SERVICE 		1
		X 94.142-26

Model 394

503 74 30-01

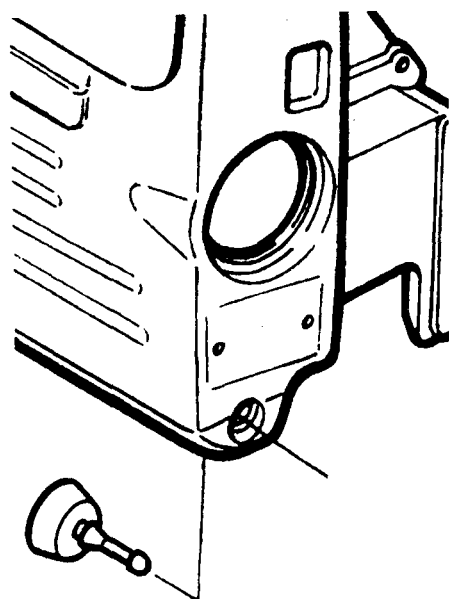
In order to receive an improved function, the front left rubber side support is made larger. This prevents the support from changing position in case the saw gets stuck.

NOTE! Only the front left rubber side support is replaced.

New Ref. No.	Description
503 74 30-01	Rubber side support

Introduced from serial number: 4020251
